DOCUMENTS FOR REVIEW AND FILES LOCATION

Please charge time to 5600015- 102. Design Consultant response period: 12-22-2014 to 1-12-2015.

TOWN OF COLCHESTER COUNTY OF CHITTENDEN PROPOSED IMPROVEMENT SIDEWALK AND RESURFACING PROJECT STP 5600(15)

**CONCEPTUAL PLANS
NOVEMBER 24, 2014**

PROJECT NAME:	COLCHESTER	PLOT DATE:	11/24/2014
PROJECT NUMBER:	STP 5600(15)	DRAWN BY:	T. DUGUAY
FILE NAME:	General Plans.dgn	CHECKED BY:	J. LEINWOHL
PROJECT LEADER:	J. LEINWOHL		
DESIGNED BY:	T. DUGUAY		
<b>TROY AVENUE PAVING PLAN TA-01</b>		SHEET	33 OF 35

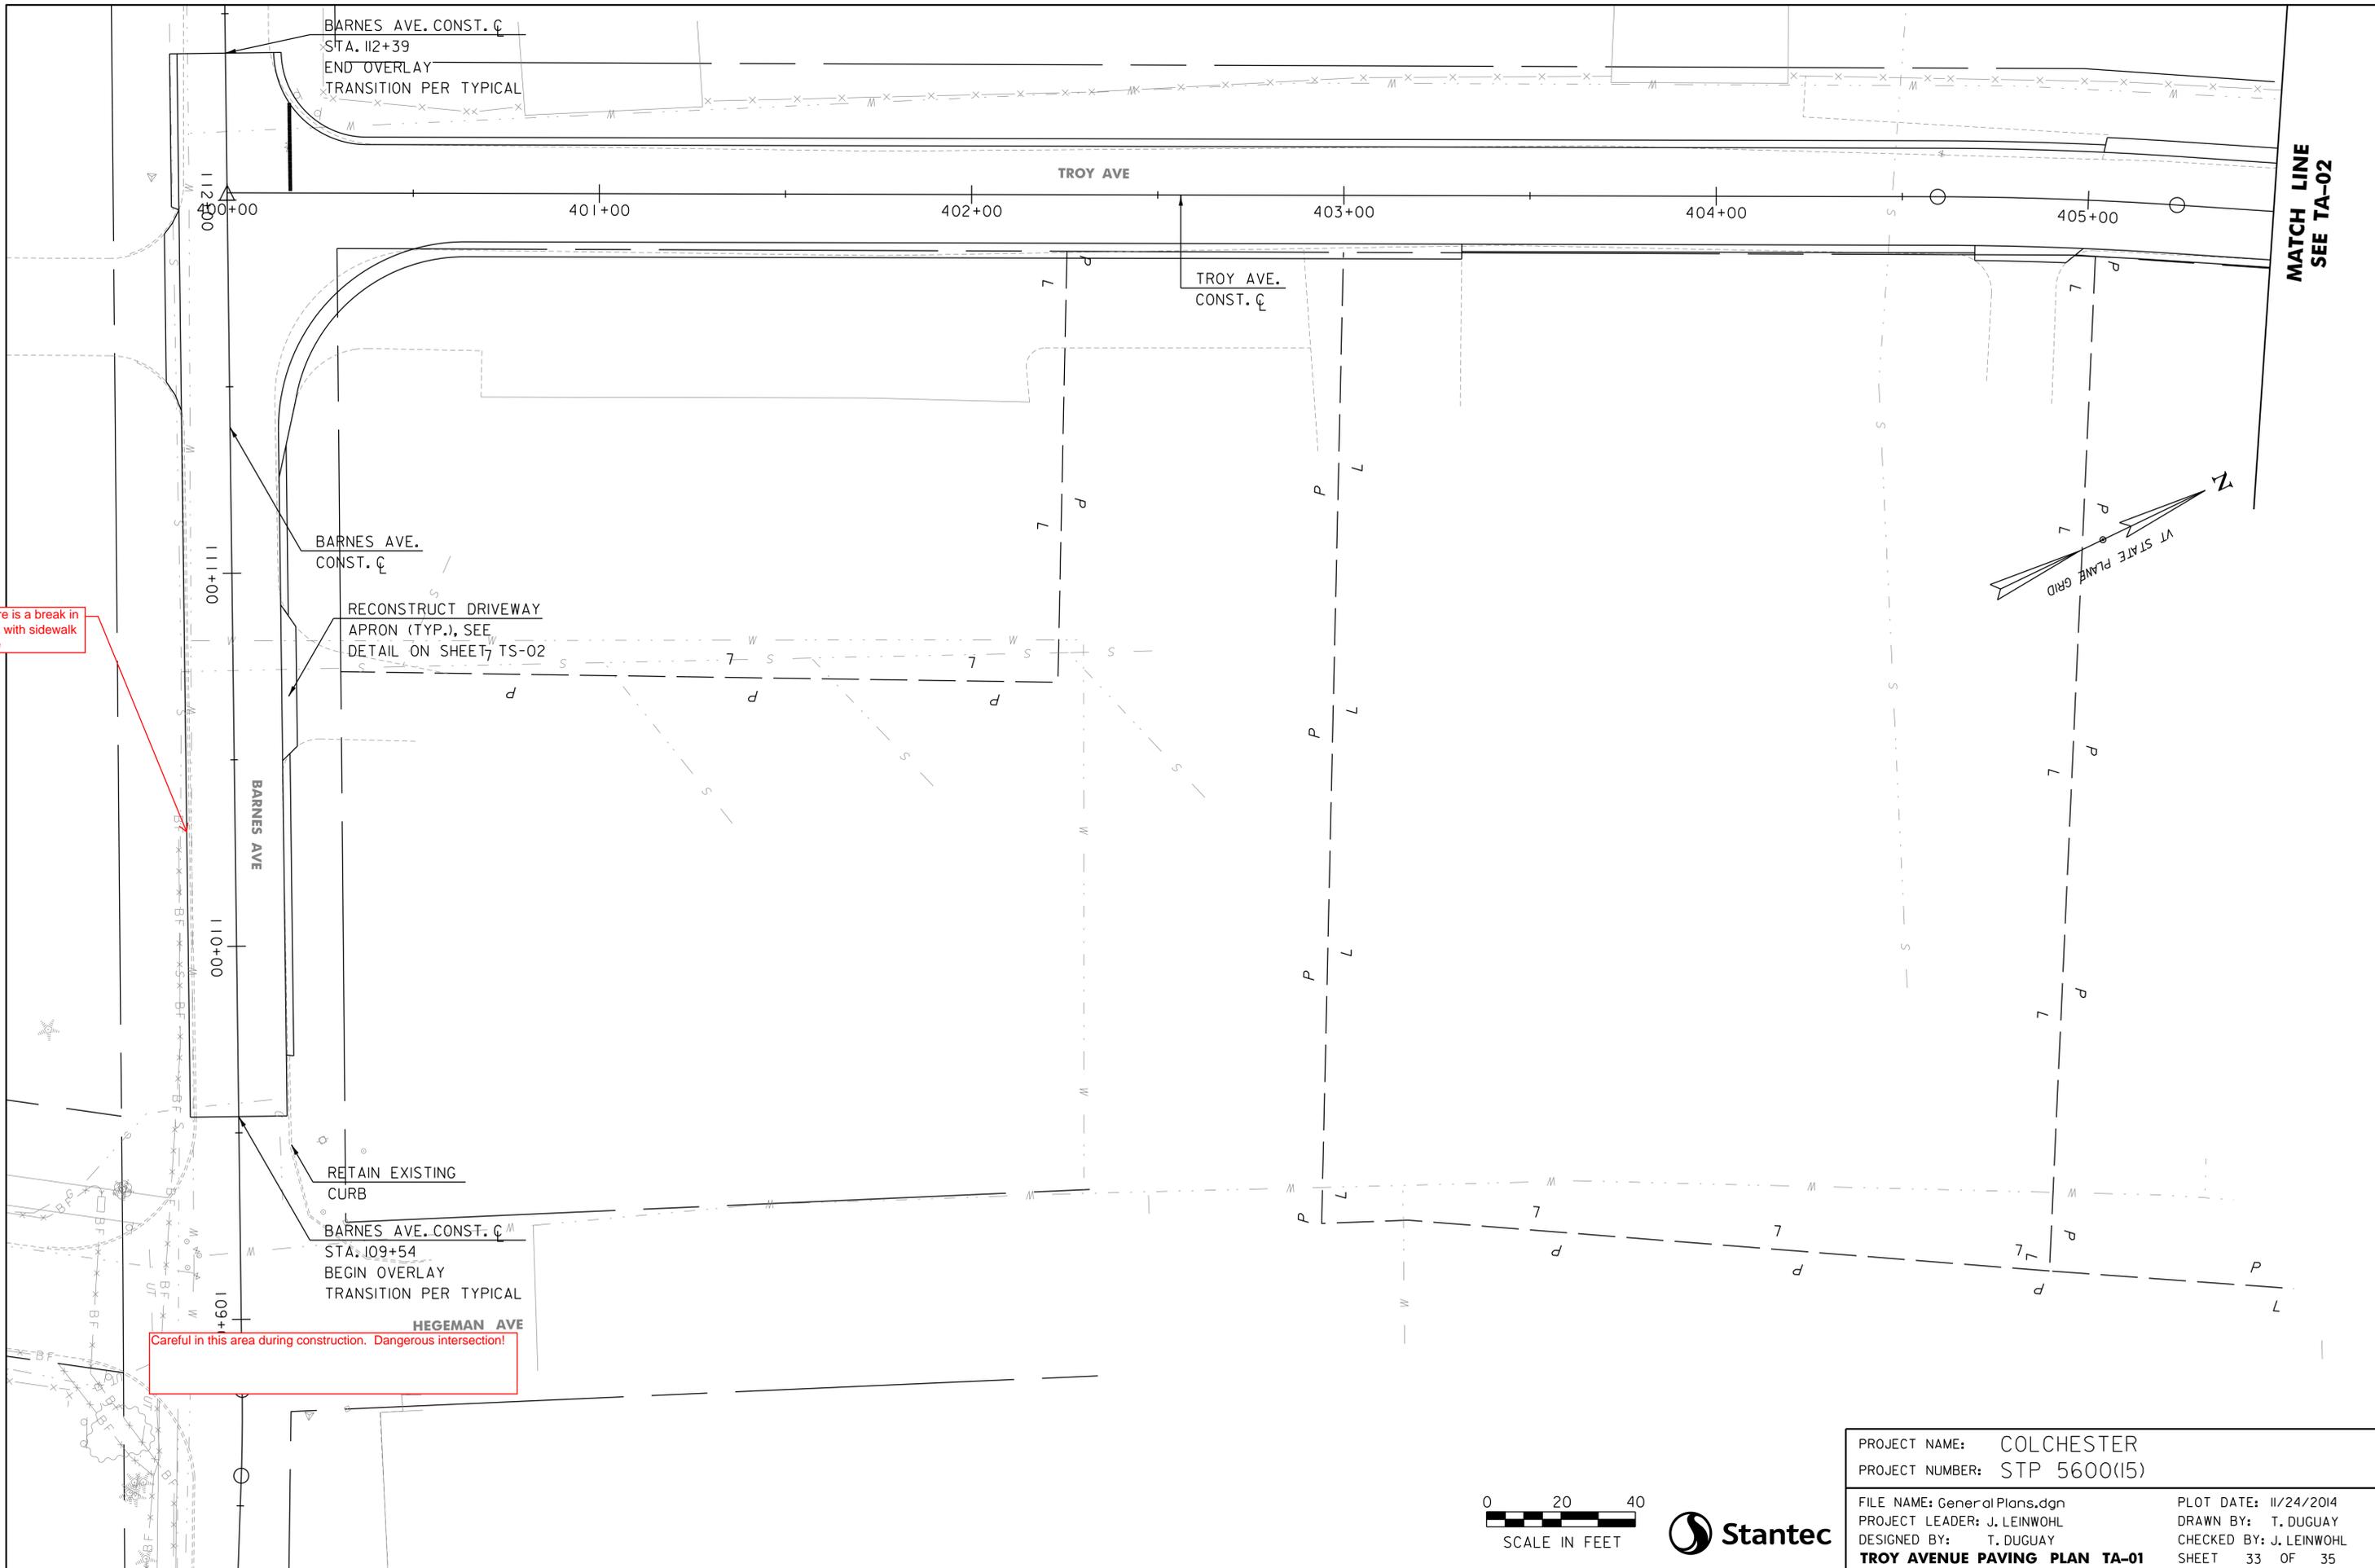
There is a break in curb with sidewalk here

Careful in this area during construction. Dangerous intersection!

PROJECT NAME:	COLCHESTER	PLOT DATE:	11/24/2014
PROJECT NUMBER:	STP 5600(I5)	DRAWN BY:	T. DUGUAY
FILE NAME:	General Plans.dgn	CHECKED BY:	J. LEINWOHL
PROJECT LEADER:	J. LEINWOHL		
DESIGNED BY:	T. DUGUAY		
<b>TROY AVENUE PAVING PLAN TA-03</b>		SHEET	35 OF 35

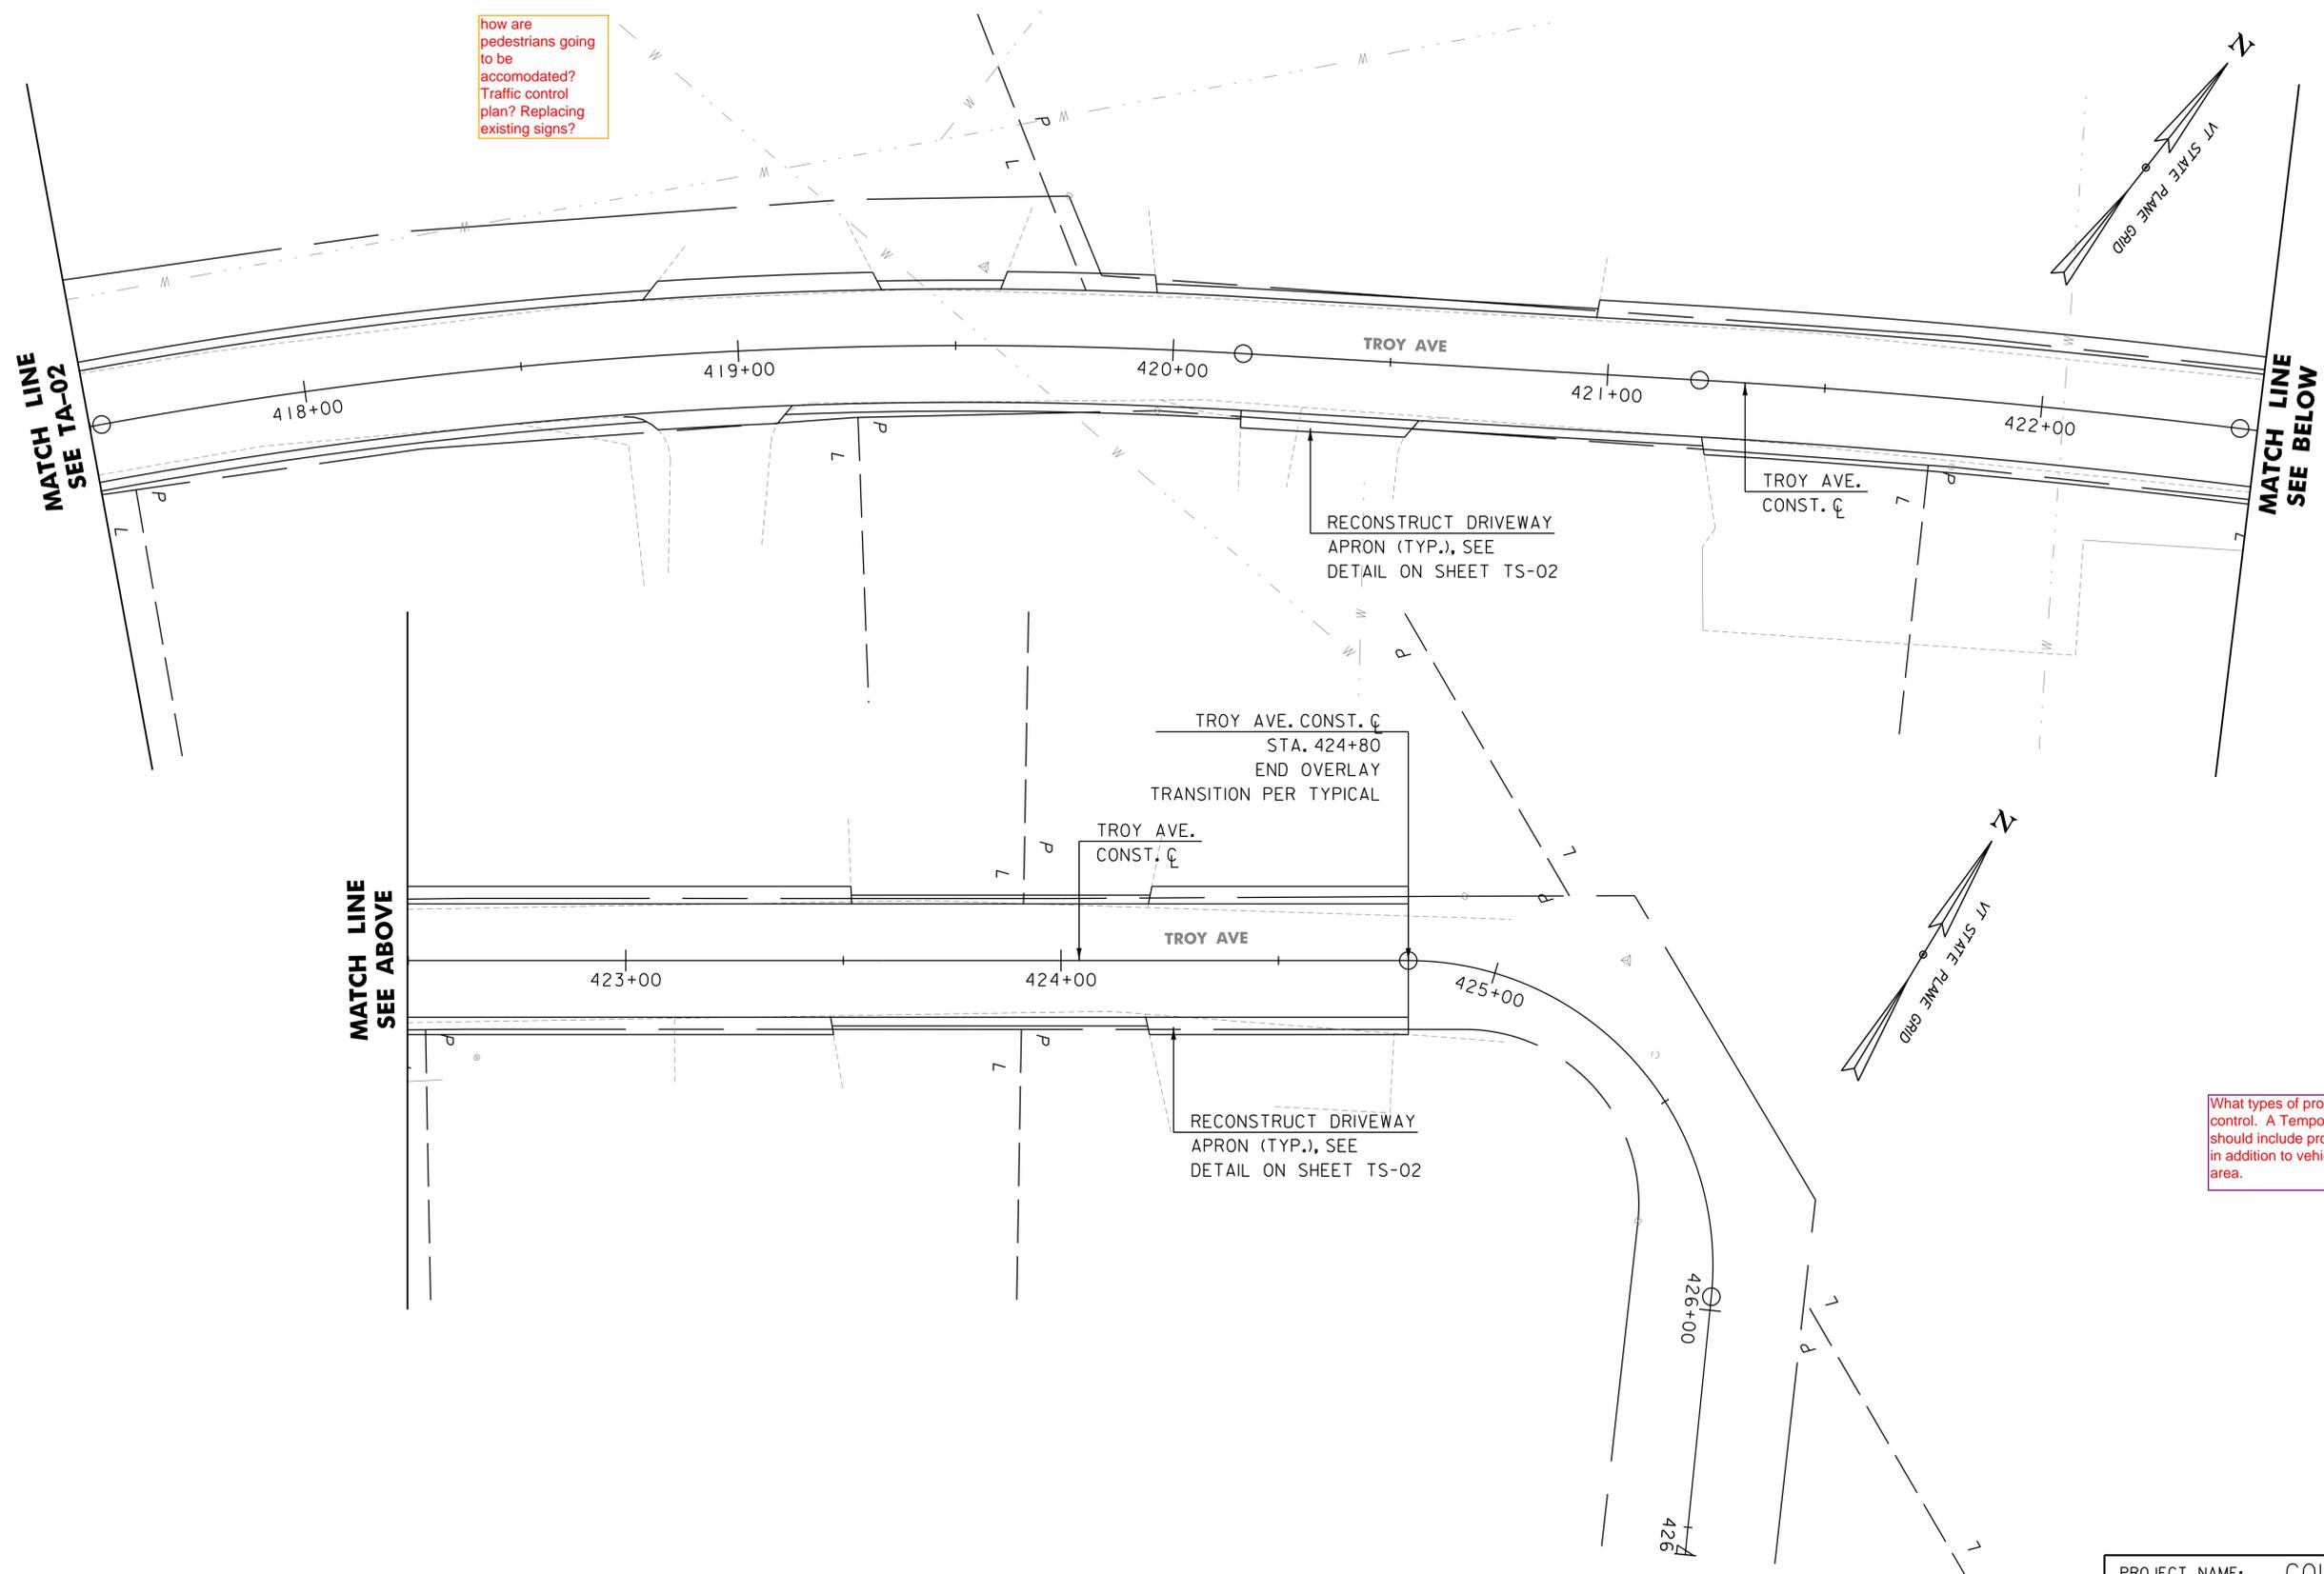
how are pedestrians going to be accommodated? Traffic control plan? Replacing existing signs?

What types of provisions have been made for traffic control. A Temporary Traffic Control plan is required that should include provisions for pedestrian and bicycle traffic in addition to vehicular traffic. Complex is a very busy area.
